BURLINGTON DEVELOPMENT REVIEW BOARD

Tuesday November 18, 2014

To: Development Review Board
From: Mary O'Neil, AICP, Senior Planner *monail*
Date: November 18, 2014
RE: ZP15-0539SP; 289 College Street

Request: Sketch Plan review for addition to existing mixed use (office/1 residence) historic building; addition to include 12 apartments, flat roof connector building with lobby, exercise room, storage, laundry, mechanicals. Parking for 20 cars in rear lot; reduced from current parking size.

SKETCH PLAN

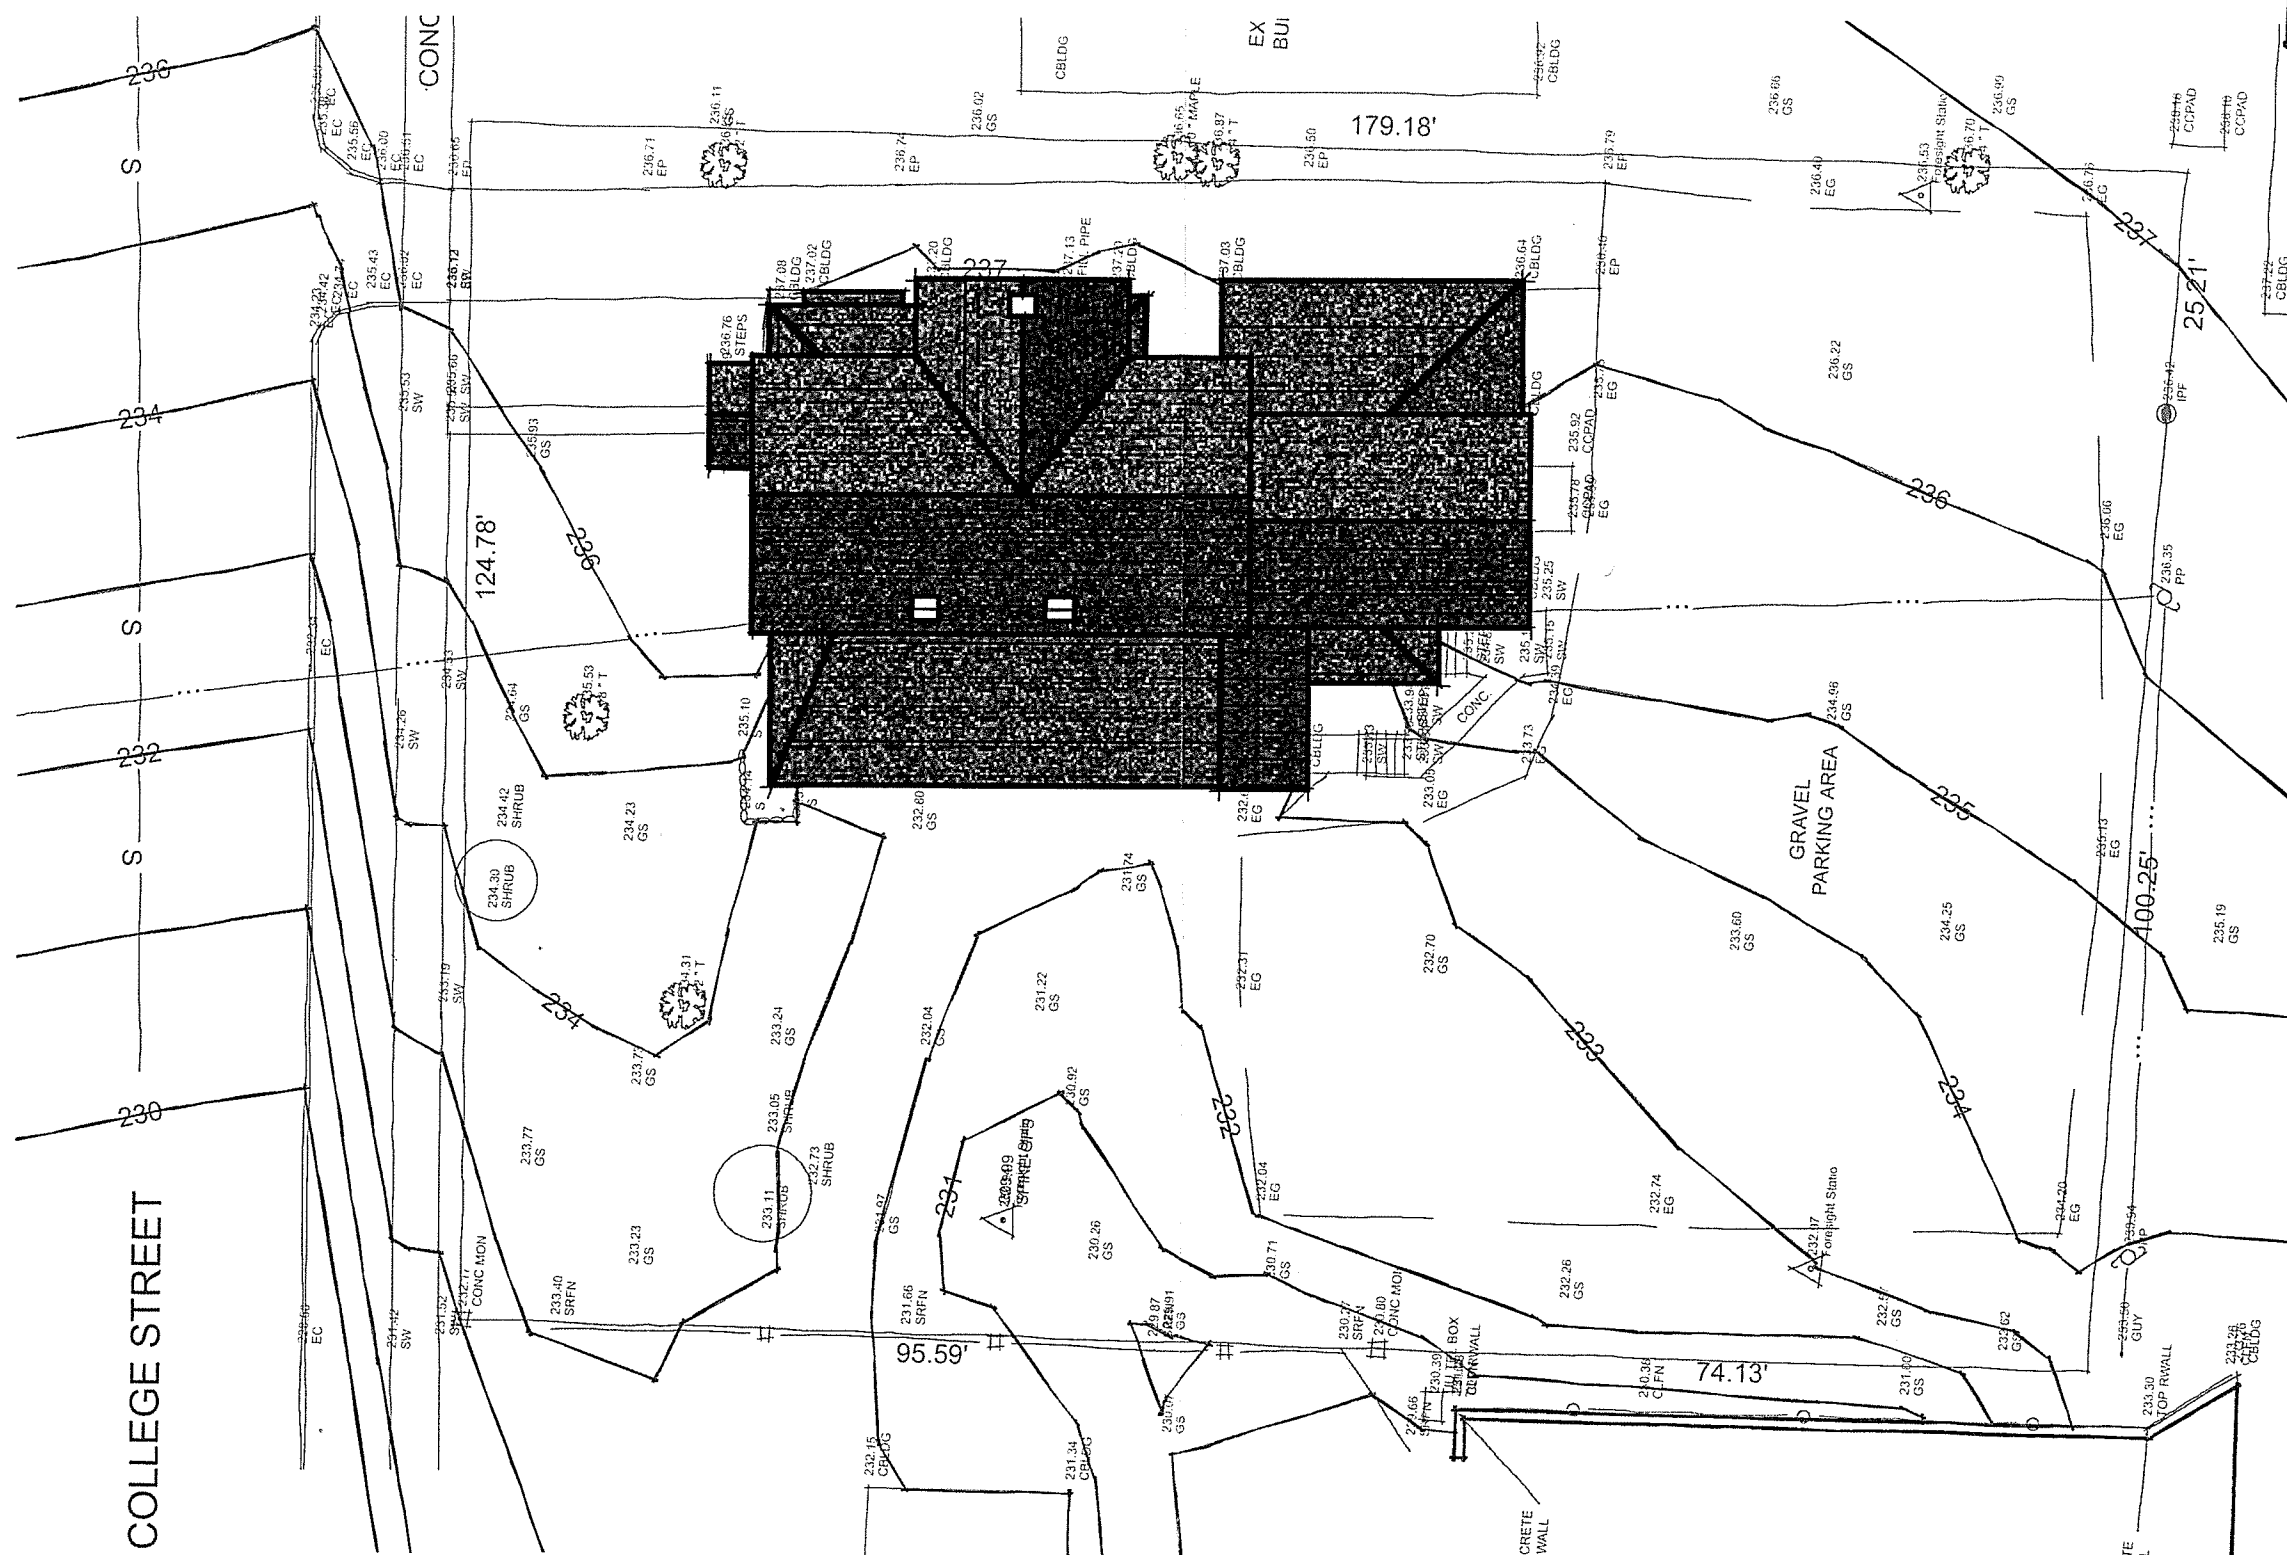
As noted, a walkway is illustrated on the modeling studies as an entrance to the rear porch area. This will need to be defined on a final site plan to assure safe passage between vehicle parking and building entrance.

No definition is given on the submitted site plan. A landscaping plan will be required. Although it appears that a property survey has been done (spray paint on the ground), no pins were observed at the site visit. As the parking area almost immediately abuts a playground on the south, it is advised that a fence or structural barrier be provided to prevent vehicular trespass onto that property. Similarly, headlamp glare may create a nuisance for those properties immediately to the south, and could be ameliorated with appropriate screening.

All parking spaces should be the minimum size required by Table 8.1.11-1; that is, 9' x 20'. The submitted site plan defines the spaces in the southerly row as 8'10", which is sub-standard. They also scale to about 18'6" in length, also less than the standard requirement. Although the parking area is existing, efforts should be exercised to meet the minimum parking requirements of the ordinance.

Proposed Site Plan

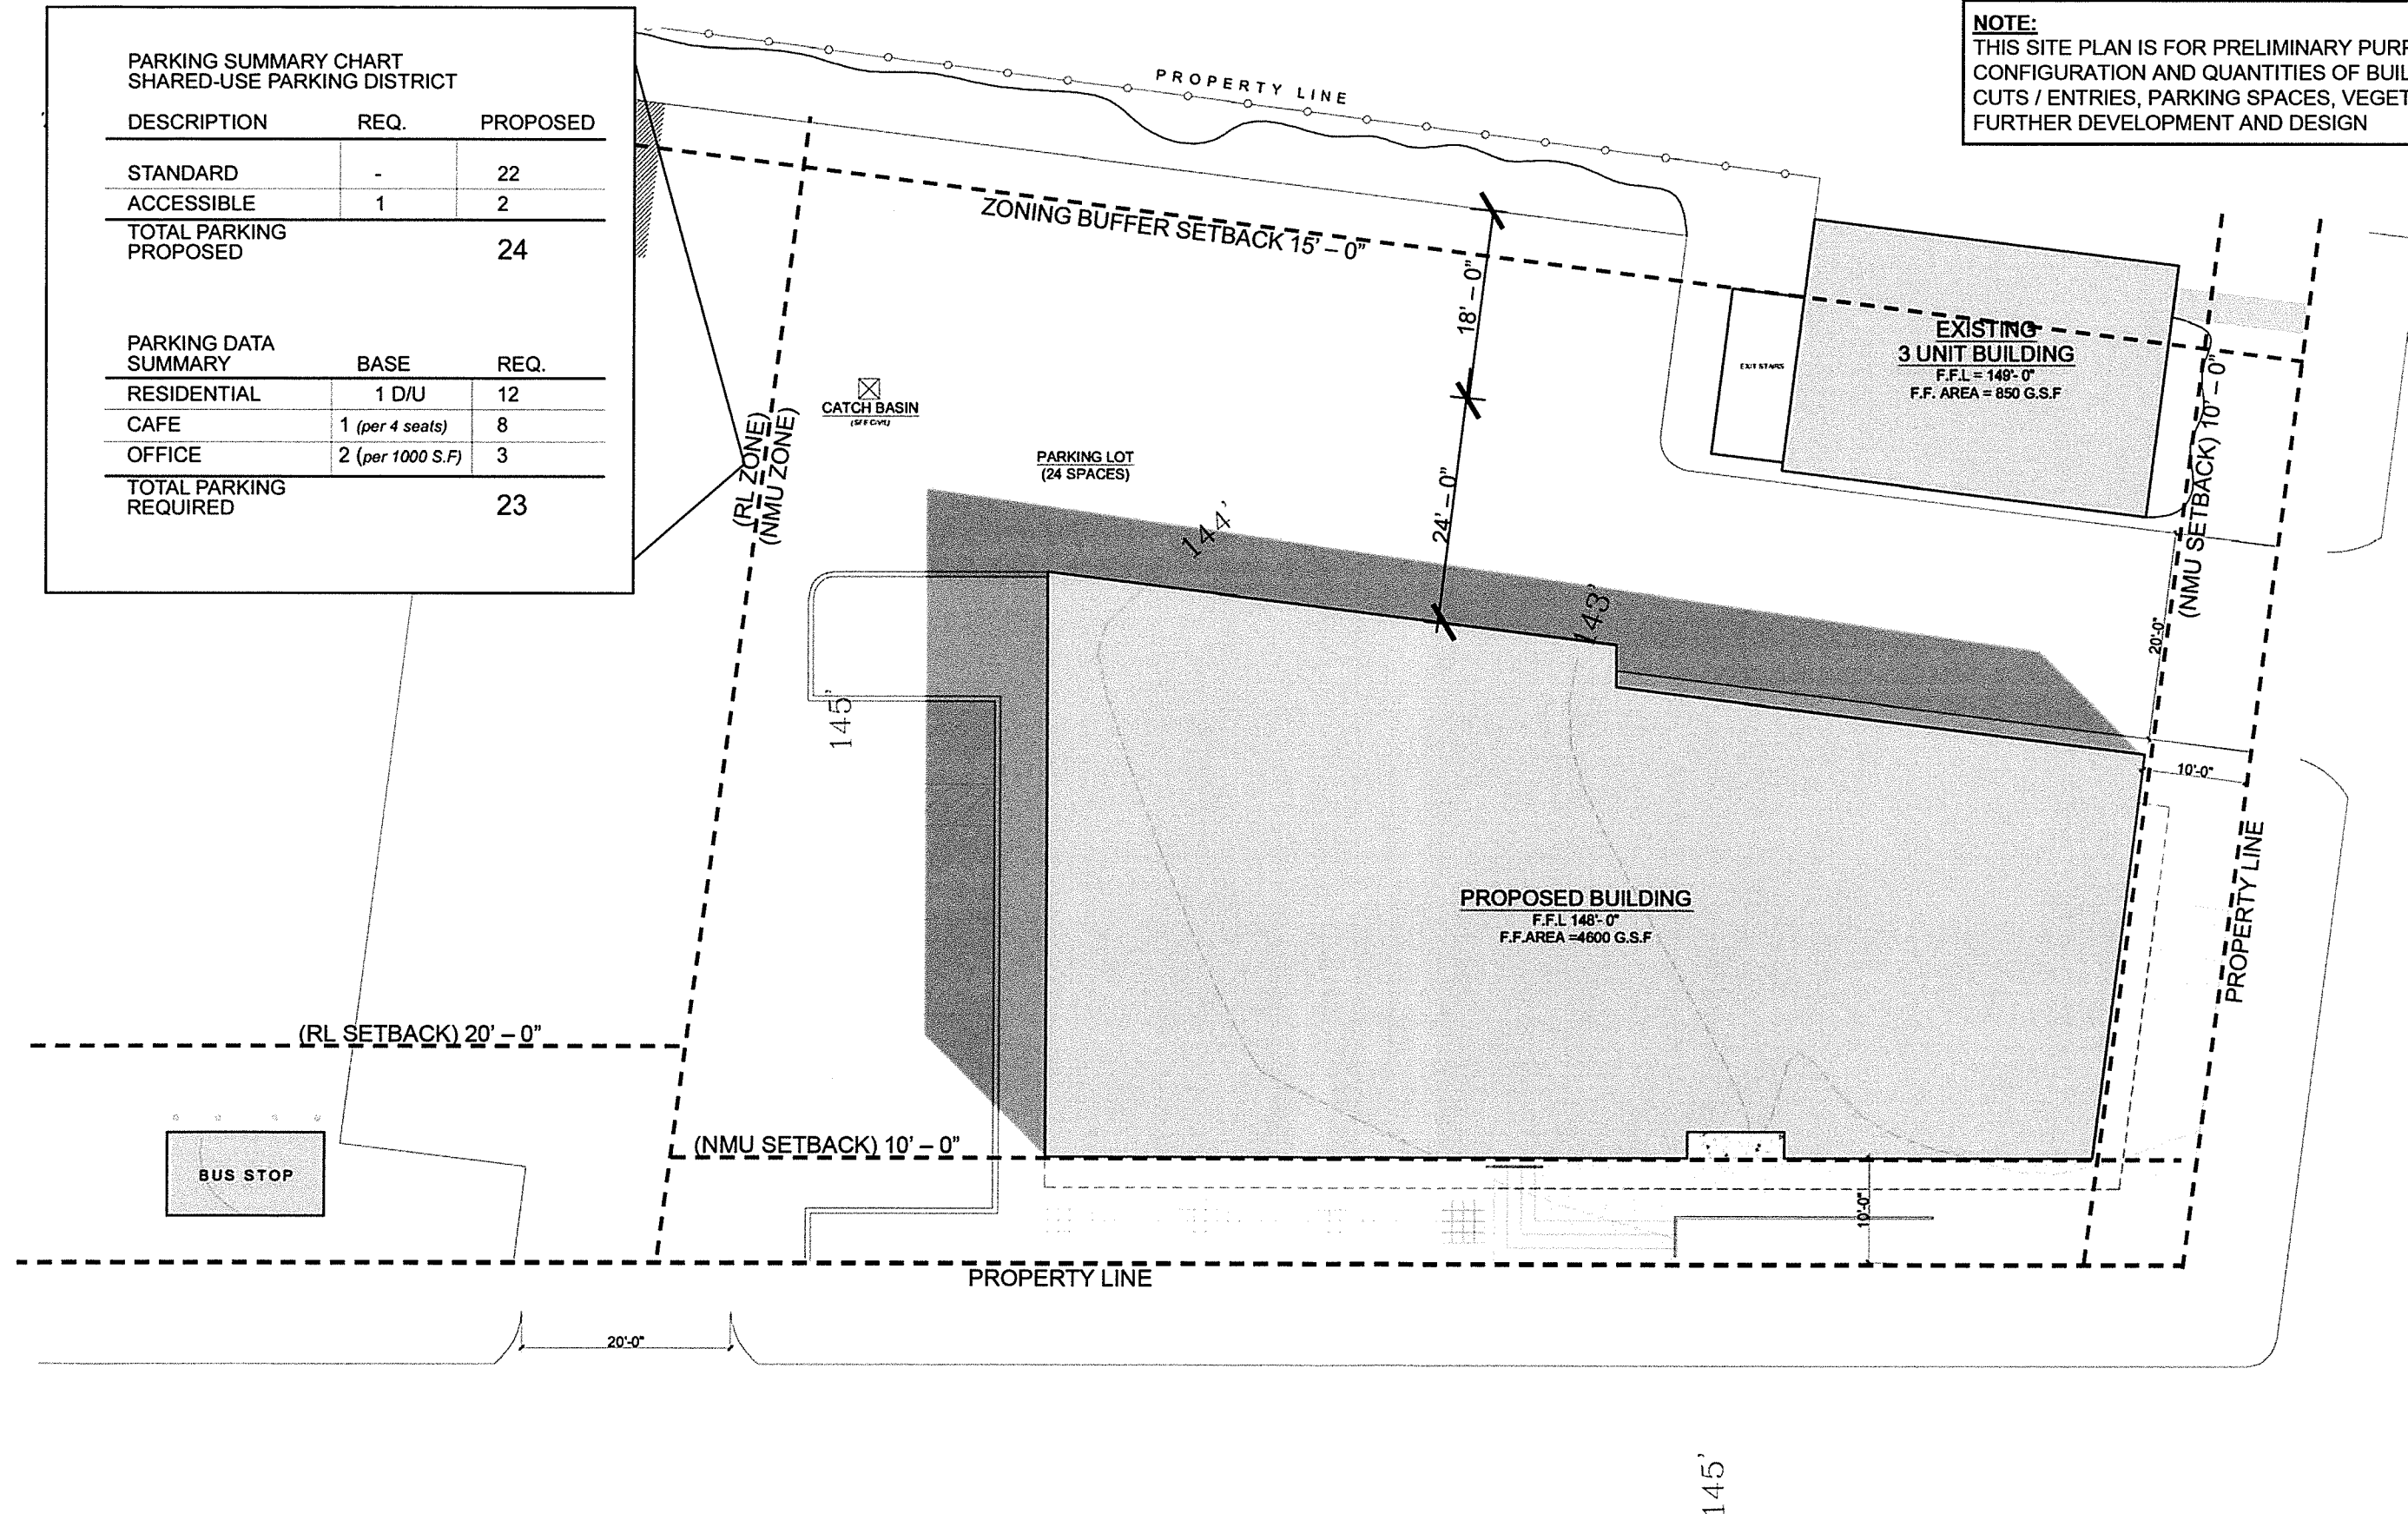
FAR in the NMU zone is limited to 2.0. The subject property is 26,424 sf (with 16,420 sf in the NMU zone). Gross square footage is 19,180 sf or 1.2 FAR relative to the NMU portion of the property. The sketch plan notes a FAR of 0.36 and needs to be corrected for the formal permit application.

Maximum permissible lot coverage is 80% in the NMU zone and 35% in the RL zone. The sketch plans note that coverage in the NMU portion will be 71% and will be 42% in the RL portion; however, the 71% is inaccurate for the NMU portion of the property. The 71% is based on 18,776 sf coverage on the entire property. Coverage within the NMU zone needs to be noted, and it needs to be based on just that portion of the property within the NMU zone. The 42% RL coverage appears to be accurate. Existing coverage in the RL portion is nonconforming at 45%. The reduction to 42% is acceptable.

The sketch plans include a proposed landscaping scheme. As noted above, revisions will be needed in order to achieve the necessary parking lot shading. Most of the landscaping consists of hydrangeas and tiger lilies. The plant list notes 20 crab apple trees; however, the plan only depicts 3. Landscaping is concentrated in garden beds in front of the existing and proposed buildings. No new landscaping is proposed in front of the Pine Street parking lot. New landscaping, particularly trees and shrubs, should be installed here to screen the parking lot from the street.
